Wichita-Sedgwick County Metropolitan Area Planning Department

Re: CON2002-00051: An administrative adjustment to Condition #4 of CON2002-00018.

VOICE STREAM PARKING LOT EXPANSION
PROJECT NAME

ELECTRICAL SITE PLAN
SHEET TITLE

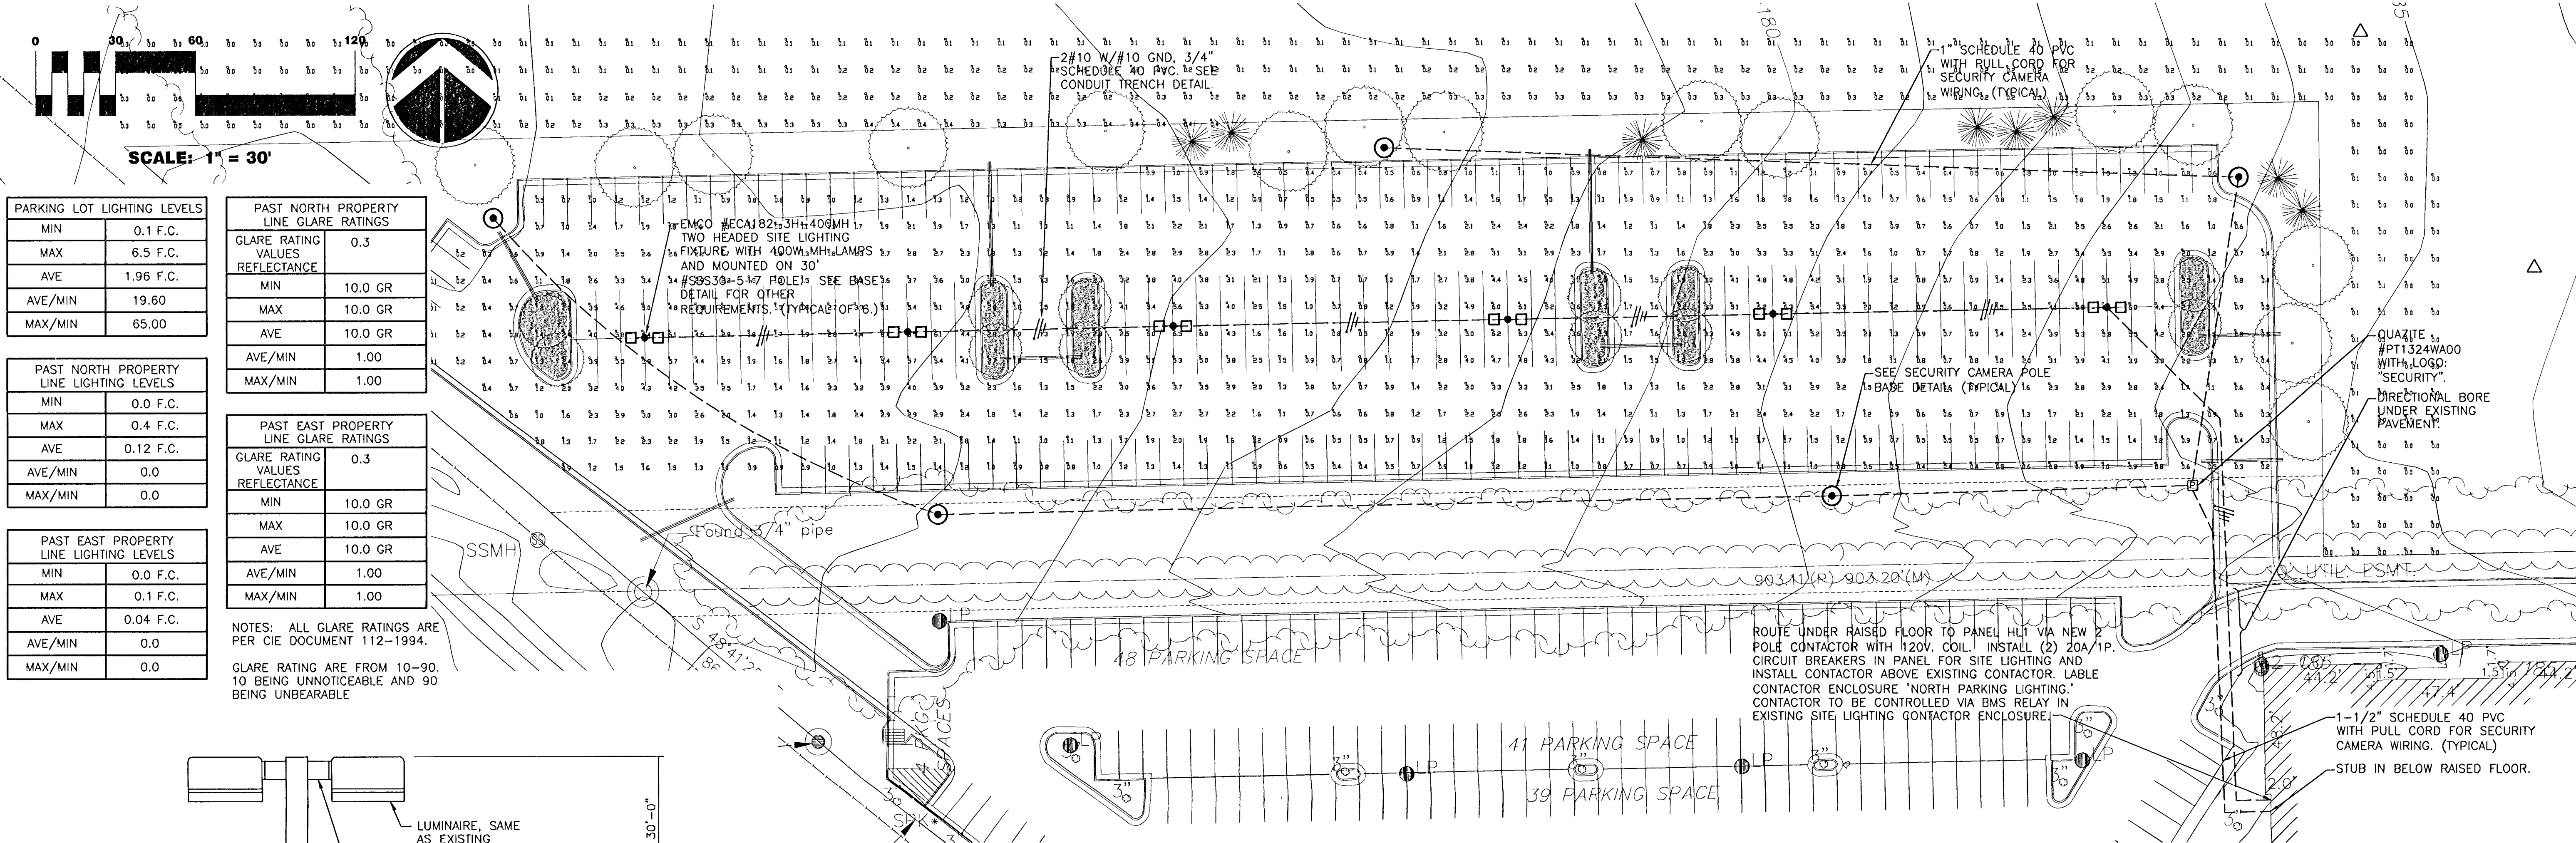
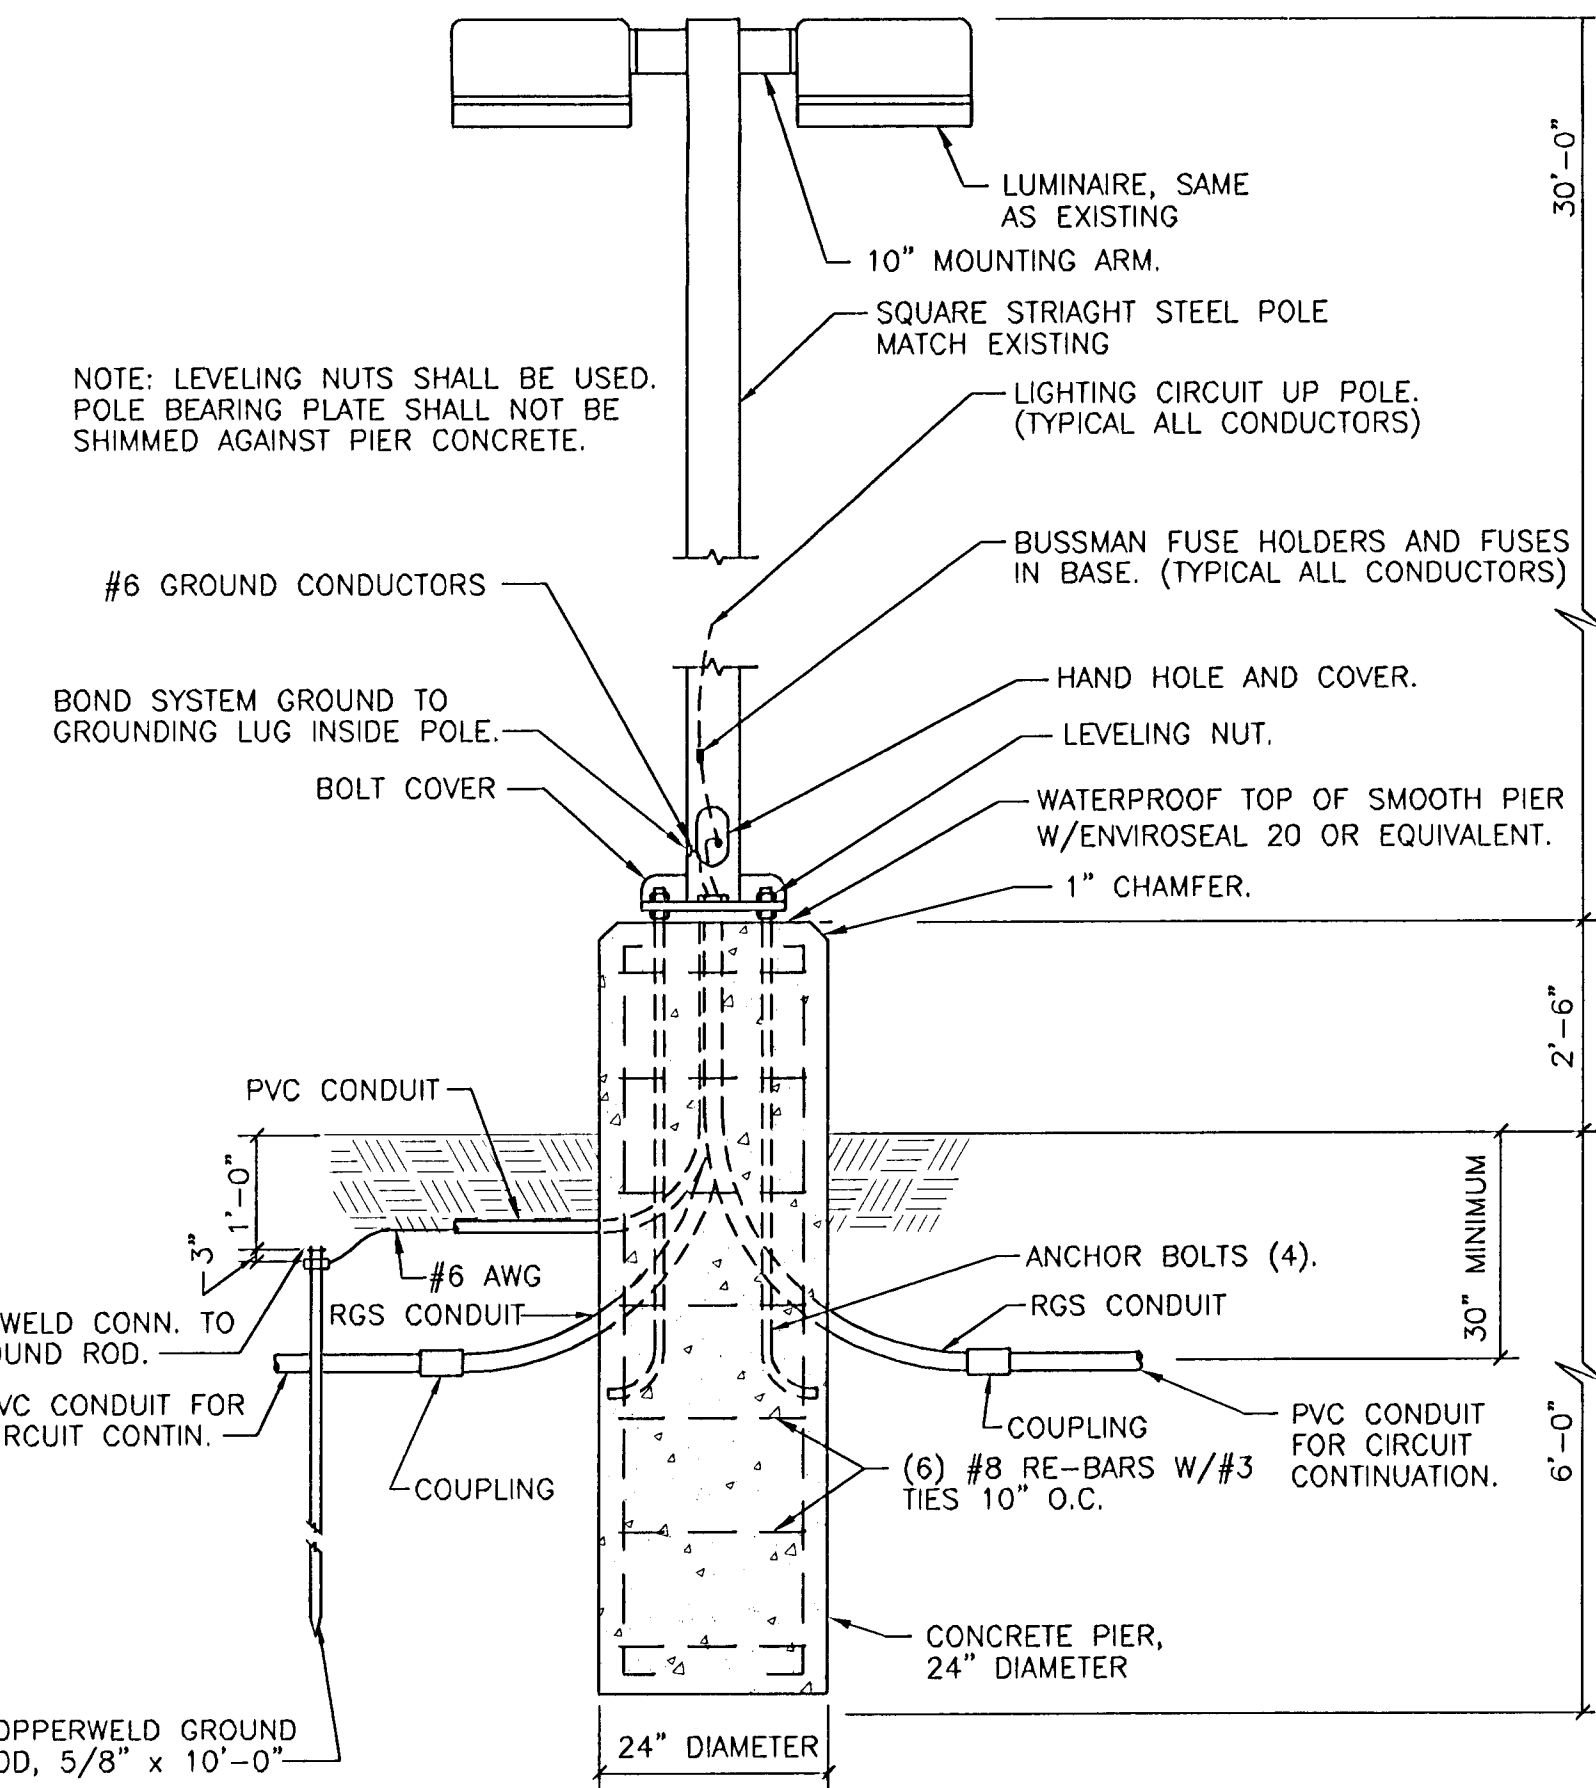
We have reviewed your request for an administrative adjustment to the site plan for CON2002-00018. You state in your application that you desire to adjust Condition #4 to increase the height of light poles and fixtures from a maximum height of 14 feet to a maximum height of 30 feet. The light poles would be placed in the center of the parking lot and be located no closer than 70 feet from the property line of residential zoning.

- 1) Impact on safety and convenience of vehicular and pedestrian circulation: The use of taller light poles and fixtures is intended to increase the safety of the parking lot for the patrons.
- 2) Impact on existing uses in surrounding areas: The taller light poles and fixtures would be located in the center of the lot by a distance of at least 70 feet to any residential property line.

This exceeds the minimum distance from a residential lot line of 60 feet for a 30-foot pole required by the Unified Zoning Code. Additionally, the adjusted landscape plan and concurrent adjustment of Condition #2 of this Conditional Use, provides for a denser landscape buffer along the north, east and west property line, which should further mitigate negative impacts on surrounding residential areas.

Our signatures below indicate that an administrative adjustment to CON2002-00018 Condition #4 to increase the height of light poles and fixtures to 30 feet on the aforementioned property is hereby granted subject to the following conditions:

- 1) Any poles and fixtures higher than 14 feet shall be at least 70 feet from any property line zoned for residential use.
- 2) Condition #2 shall be adjusted to require a landscape buffer along the screening wall on the north and east property lines to be increased to one tree every 30 feet, with at least one-half being evergreen, and an additional three evergreen trees shall be added to the northern 80 feet of the drive aisle on the western property line of the parking lot.
- 3) The lighting shall meet all other standards of Unified Zoning Code Article IV, Section IV-B.4.
- 4) The site shall be developed in general conformance with the site plan.
- 5) All conditions of approval, as modified by this adjustment, for CON2002-00018 shall be met.
- 6) Any violation of these conditions shall render the Administrative Adjustment null and void.
